# Access Compliance Report

## Public Rights-of-Way

### (Curb Ramps)

Intersection ID: 11363	Main Street: N_POPLAR_ST	Cross Street: W_12TH_ST	Location: E
ADA ID: EFFE940C423B	Ramp Type: Para	Initial Pass/Fail: Fail	Overall Compliance: No
		Severity Score: 12.5

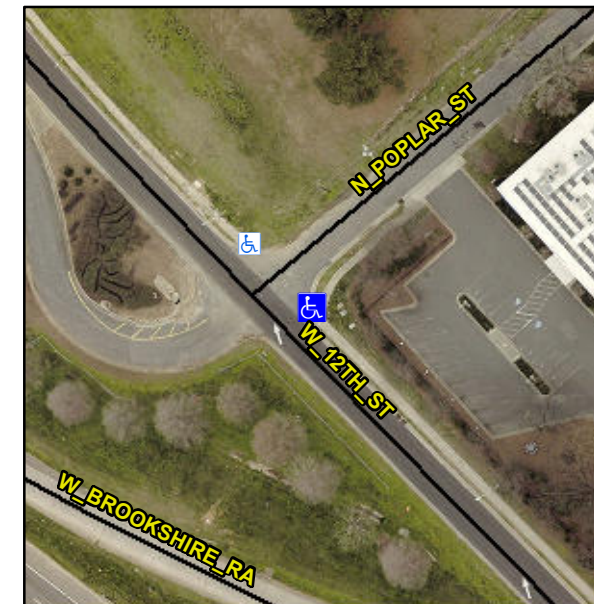
**RT RP < 5%**

**R304.3.2**

Compliance	Description	Data	Compliance	Description	Data
N/A	Ramp Length LT (in)	37.5	N/A	Ramp Length RT (in)	21.5
Yes	Ramp Width LT (in)	65.5	Yes	Ramp Width RT (in)	57.5
No	Ramp Slope LT (%)	10.4	Yes	Ramp Slope RT (%)	0.8
Yes	Ramp XSlope LT (%)	0.1	Yes	Ramp XSlope RT (%)	1.1
N/A	Landing Length (in)	N/A	N/A	DWS Provided?	N/A
N/A	Landing Width (in)	N/A	N/A	DWS Contrast?	N/A
N/A	Landing Slope (%)	N/A	N/A	DWS Length (in)	N/A
N/A	Landing X Slope (%)	N/A	N/A	DWS Full Width?	N/A
N/A	Landing Curb? (Y/N)	N/A	N/A	DWS Offset (in)	N/A
N/A	Shared Landing?	N/A			
N/A	Gutter Ponding?	N/A	N/A	Gutter Slope (%)	N/A
N/A	Gutter Lip Ht (in)	1.5	N/A	Gutter X Slope (%)	N/A
N/A	Painted X Walk1?	No	N/A	Painted X Walk2?	N/A
	X Walk 1 Direction	To NW		X Walk 2 Direction	N/A
N/A	X Walk 1 Width (in)	N/A	N/A	X Walk 2 Width (in)	N/A
	X Walk 1 Slope (%)	4.0		X Walk 2 Slope (%)	N/A
	X Walk 1 X Slope (%)	1.7		X Walk 2 X Slope (%)	N/A
N/A	Ramp inside XWalk1?	N/A	N/A	Ramp inside XWalk2?	N/A

**Remove & Replace Entire Ramp.**
